**Re: Del Norte Baptist Church  
5800 Montgomery Blvd. NE  
Grading & Drainage Plan Engineer's Stamp Dated 8/1/17  
(G18D010)**

Based upon the information provided in the submittal received on 8/2/17 the above-referenced plan cannot be approved for Grading, SO-19, and Paving Permits.

**Rio Grande Engineering**  
1600 CENTRAL AVENUE SE  
SUITE 201  
ALBUQUERQUE, NM 87106  
(505) 871-0000

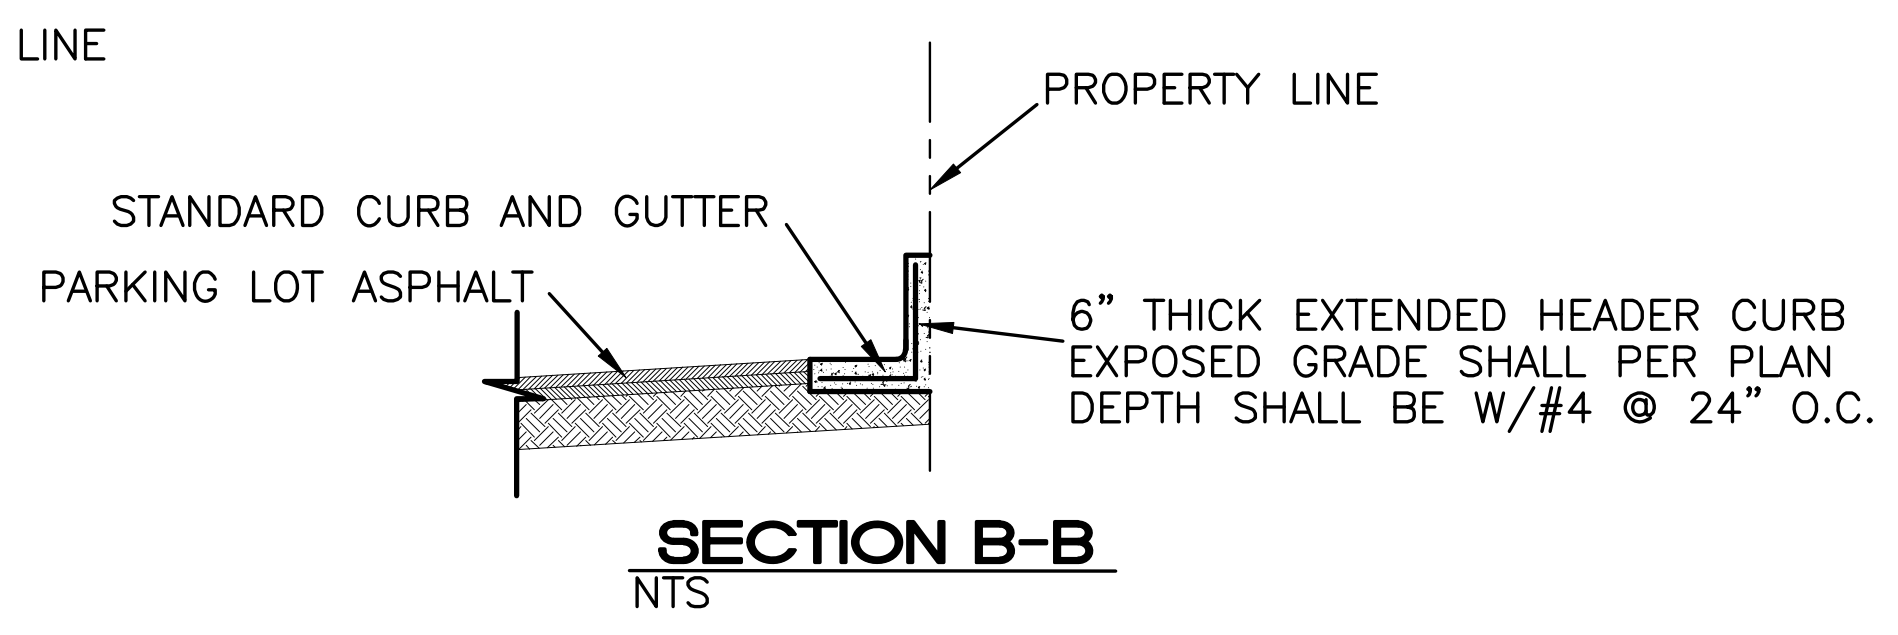
- Add more typical sections around perimeter of site. More retaining walls may be needed particularly along the west side of lots C and B. Show existing walls/slopes in sections.

- Typical section DD needs more dimensions, show footer, existing ground distance to property line, and max height of retaining. Offset the wall far enough from property line so that the neighbor's property will not be disturbed during construction.
- Add existing ground and dimensions to Section BB
- Provide more sections and details for grading in landscape areas northeast of the building.
- Provide HGL calculations for onsite storm drain and add profile of pipe to the plans showing HGL and label HGL elevations, Q, and V.
- Provide actual flow depth & elevation at inlets. Add emergency overflow depth & elevation calculations for sump inlets and verify freeboard to building floor elevations.
- Provide section, profile, and details of ponds F and G. Make sure they do not drain into the private property west of this site. Provide outfall details.
